## Richardson (MVP) Park update and aquatics design

MVP - PHASE 1 SITEPLAN

# PORT committee feedback from January 7<sup>th</sup> meeting

## Normal operations with labels

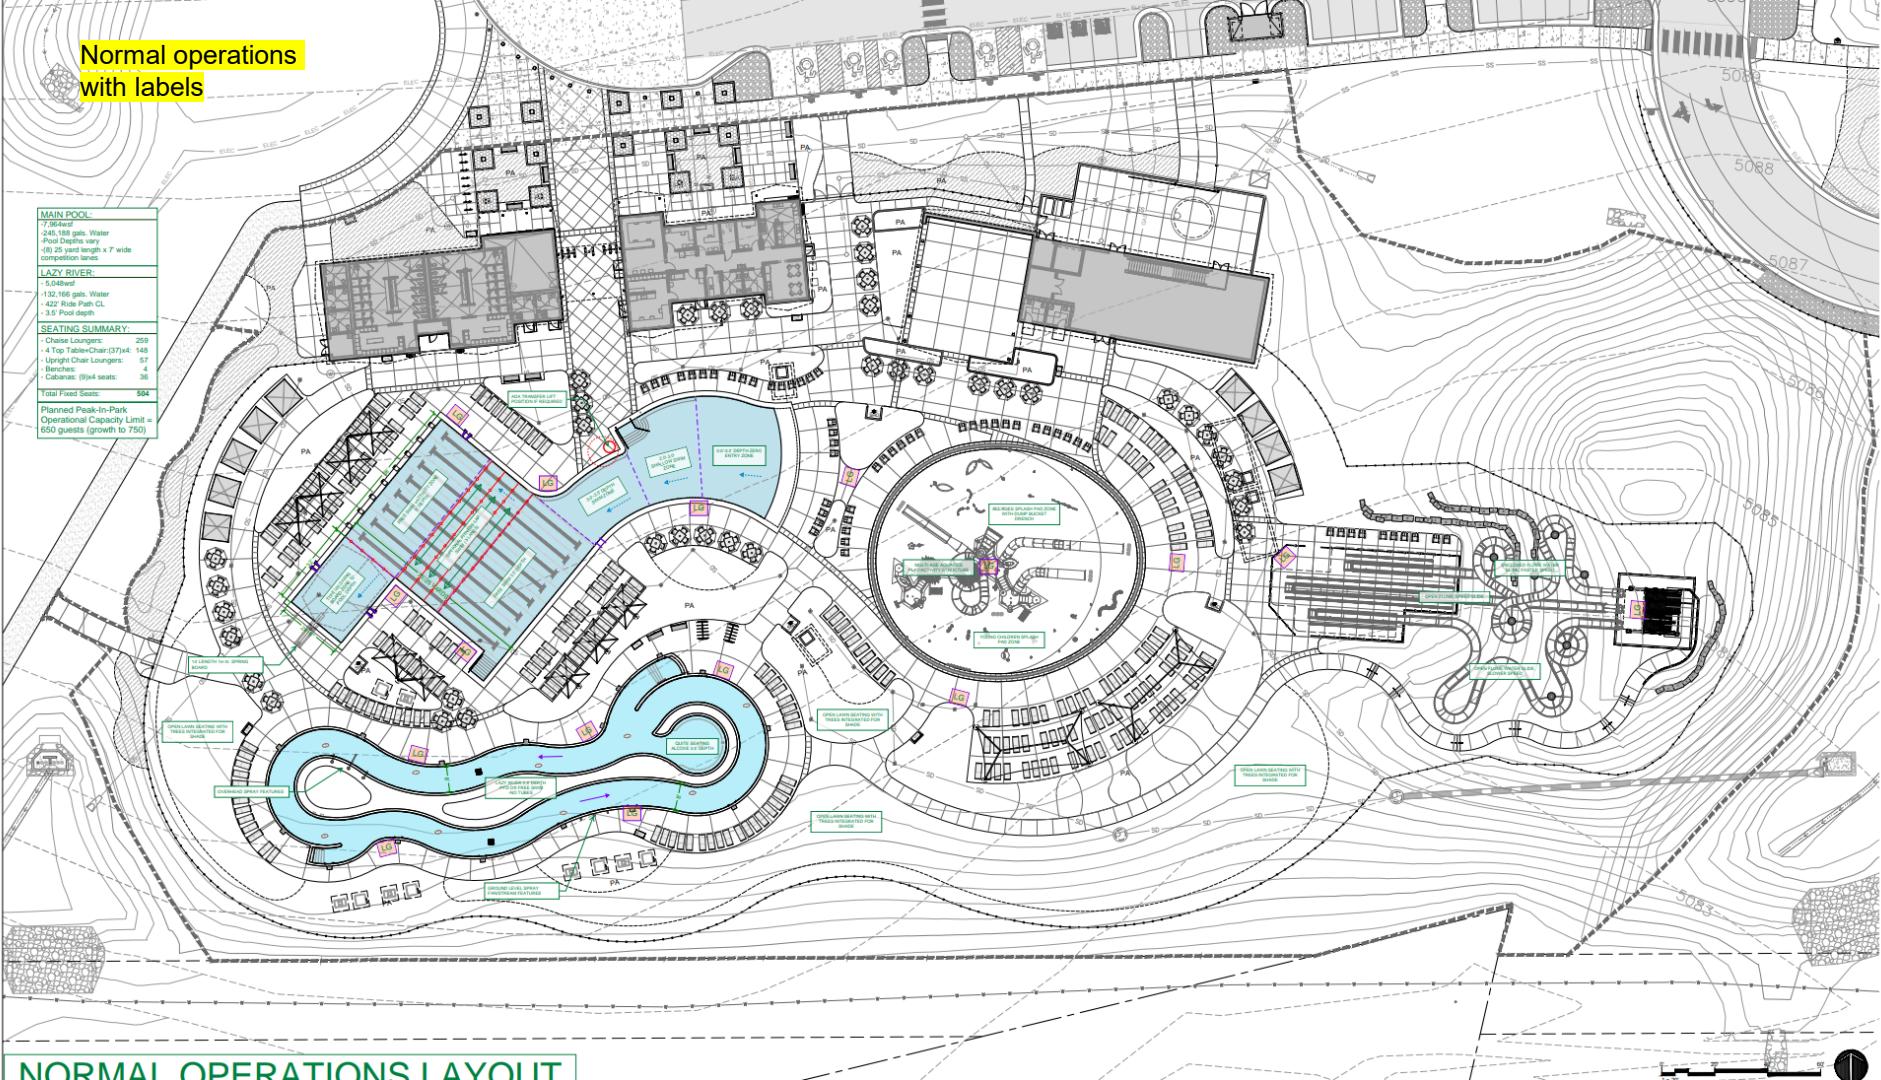
Inquired if the pool deep end could be enlarged or extended across the lap lanes:

Consideration of providing tubes for the lazy river, but wanted to make sure there would be times that tubes could be used and other times when tubes should be forbidden.

Review more grassy areas with shade, ideally tree cover. Seating and chair amounts were debated, whether we need the amount of lounge chairs vs the member opinion that we do indeed need those amounts.

Requested the gutters to be constructed flush with the wall for better user experience while lap swimming.

A desire for the outer lanes of the lap pool to be wider and look at additional exit options in the pool area.

The deep wells in the pool are the costliest portions of the project, in design and construction and operation. Enlarging the pool footprint will likely have outsized costs that will make it much harder to fund the construction of the base bid project. Extending the deep end into the lap lanes will similarly increase costs and significantly reduce the programmable 3'-6" depth areas from a maximum of 57 LF to 20 LF. Aquatics Staff and design staff has iterated frequently during the process that the 3'-6" depths are the most utilized in terms of programming and open swim opportunities as experienced at the Recreation Center pools. Additionally, aquatics staff has given input the increased safety risks of increased saves as kids have challenges staying afloat through the deeper waters. In the updated design there is 787 square feet provided of diving well space. Staff believe this can be managed effectively to provide exceptional user experience of both diving and swimming in the currently designed area.

Staff recommendation- Staff had an initial discussion with the design consultants to explore an option and a cost estimate to include a larger deep well. Doing so will incur additional cost to all upcoming phases of design, construction, and operations that will likely end up being cost prohibitive. Staff recommends leaving the depths as currently planned.

Staff recommendation- This is an operational decision. Staff will investigate further as appropriate.

Staff recommendation – Fabricated shade structures are included in the design. Trees can create additional maintenance issues and will take many years to provide meaningful shade. Seating and lounging in a pool facility is always a high priority and in high demand/desired. Staff is confident the amount of seating and lounge chairs provided in design fits the occupancy numbers (650) when open for daily swim use. No changes are needed to current plan.

Staff recommendation - This request has been reviewed and discussed previously in design with the consultant and aquatics team. The pool is designed to have overflow gutters. The Recreation Center has the overflow gutter style and is the correct application for the pool of this size and preference.

Staff comments - There is a plan to widen the outer lanes per minimal standards of competition. Additional exit options will be reviewed and updated if appropriate.
